SWCPP Ref. No.:	PPSSWC-255
DA No.:	DA22/0545
PROPOSED DEVELOPMENT:	Staged Construction of Mixed Use Residential & Retail Development including Four (4) Buildings (5 to 14 Storeys), 349 Residential Apartments, 18 Retail Premises, Two (2) Levels of Basement Car Parking, Ground Level Car Parking & Associated Site Works
PROPERTY ADDRESS:	123 Mulgoa Road, PENRITH NSW 2750 22 Ransley Street, PENRITH NSW 2750 18 Ransley Street, PENRITH NSW 2750 123 Mulgoa Road, PENRITH NSW 2750 123 Mulgoa Road, PENRITH NSW 2750 123 Mulgoa Road, PENRITH NSW 2750 123 Mulgoa Road, PENRITH NSW 2750 123 Mulgoa Road, PENRITH NSW 2750 123 Mulgoa Road, PENRITH NSW 2750 123 Mulgoa Road, PENRITH NSW 2750 123 Mulgoa Road, PENRITH NSW 2750 123 Mulgoa Road, PENRITH NSW 2750 123 Mulgoa Road, PENRITH NSW 2750
PROPERTY DESCRIPTION:	Lot 59 DP 1256085, Lot 2 DP 1263697, Lot 60 DP 1256085,
ZONING:	RE1 Public Recreation - LEP 2010 RE2 Private Recreation - LEP 2010 SP3 Tourist - LEP 2010

CLASS OF BUILDING:	Class 2 , Class 6 , Class 7a
ASSESSING OFFICER	Wendy Connell
APPLICANT:	Cabe Developments (Nsw) Pty Ltd
DATE RECEIVED:	14 June 2022
REPORT BY:	Wendy Connell, Senior Planner, Penrith City Council
RECOMMENDATIONS:	Approve

A

Above: Building L - Landscape plan roof top communal area extract

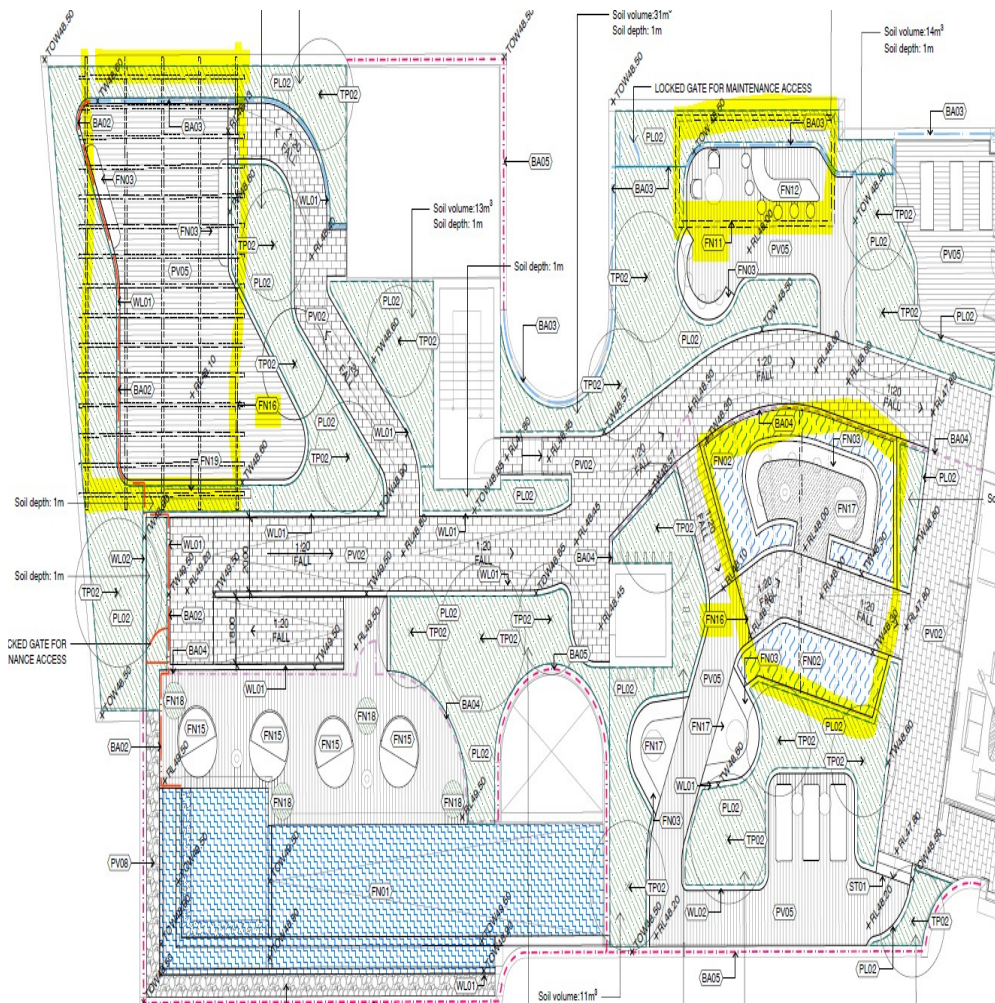
In regard to Building L, the landscape plans show RL 46.7 as the surface level height under the pergola marked with a red x below and the architectural plans indicate a roof height of RL 49.55 for Units J.501 and J502. This would allow for a pergola with a top of roof height 2.85m from the surface level which would remain under the 24m height plane. The 2.85m height limit for the pergola is likely to be too low however to avoid any further height exceedance which has not been assessed. A condition of consent requiring deletion of these structures from the plans is recommended.

Above: Building J - Landscape plan roof top communal area extract

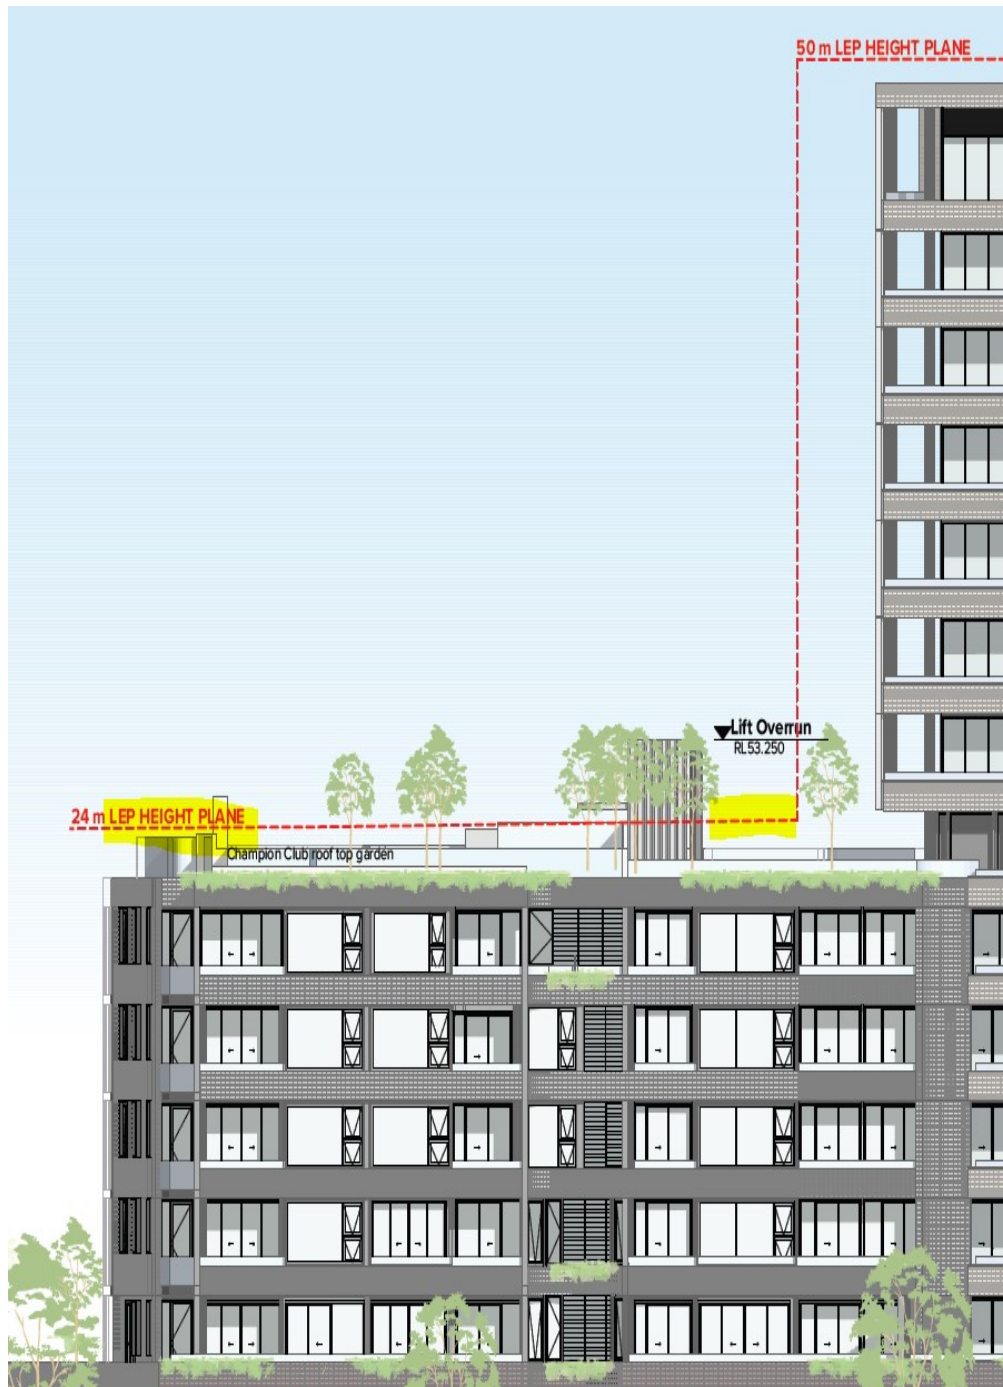
In regard to Building J, it has been assessed that a height breach is likely for the pergola structures at level 6. The TOW RL at the northern end of the swimming pool is RL 49.5 which appears from the elevation plan to include the acoustic barrier which has a height exceedance of 1m as outlined in the Clause 4.6 request. This would result in the 24m height plane being at RL48.5. The RL under the pergola structures is RL 48.10 or RL 48.0 and would require at least a 3m high pergola structure which would result in a height exceedance (RL 51.10 or RL 51.0). These structures have not been identified in the Clause 4.6 request. A condition of consent requiring deletion of these structures from the plans is recommended.

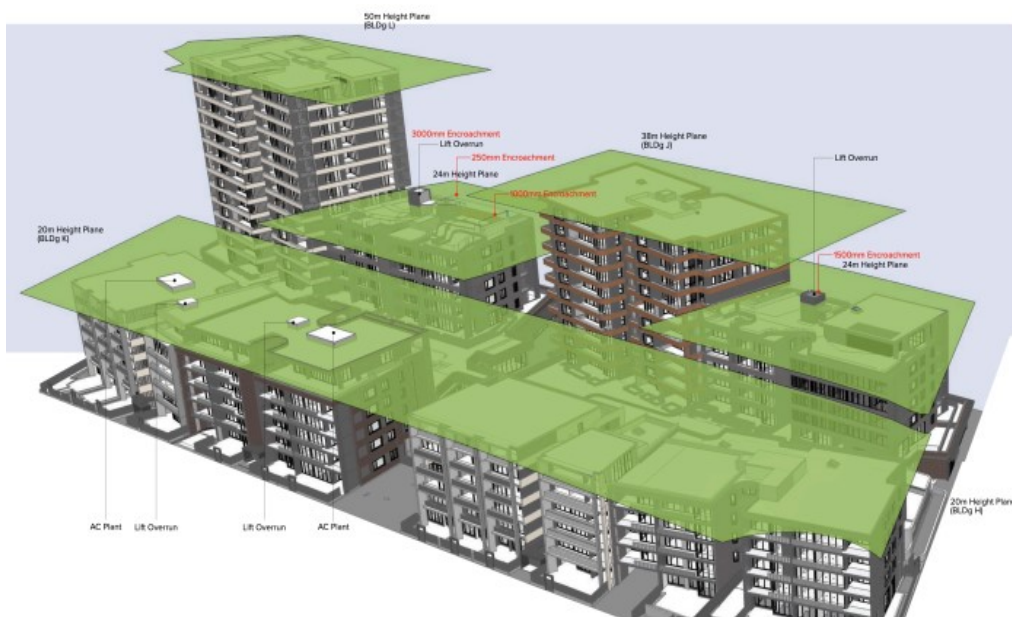
The proposal does not comply with the HOB standard. The building height breaches to the height standard are as follows:

- Building L (HOB 24m) - lift overrun 3m (12.5%) and acoustic screens 250mm to 1m (4.2%)
- Building K (HOB 20m) - 2 x plant 573mm (2.8%) and 2 x lift overruns 563mm (2.8%)
- Building J (HOB 24m) - lift overrun 1.5m (6.25%) and skylight to Unit J.501 300mm (1.25%)

Figure E13: 27 Street Wall Height

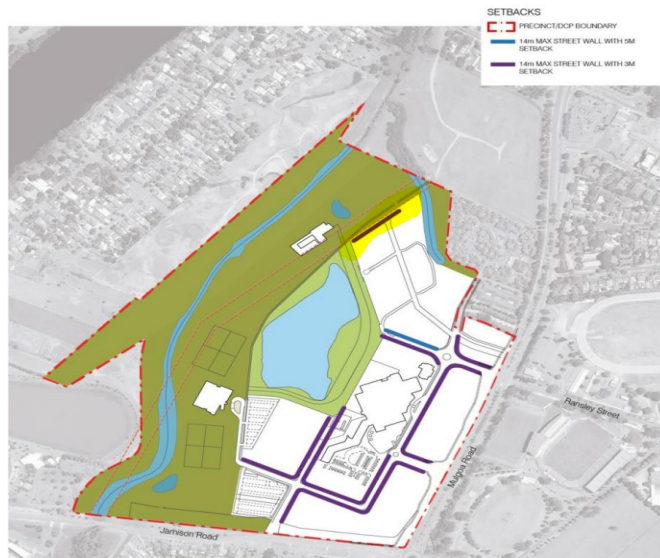
Buildings J and H do not comply with the above control as the buildings are proposed with street wall heights of 24m with a 0m setback to the boundary (see image below). In considering the objectives and the unique location of the development, a variation to this control for Buildings J and H would not result in a negative impact on the urban character of the area, nor on solar access.
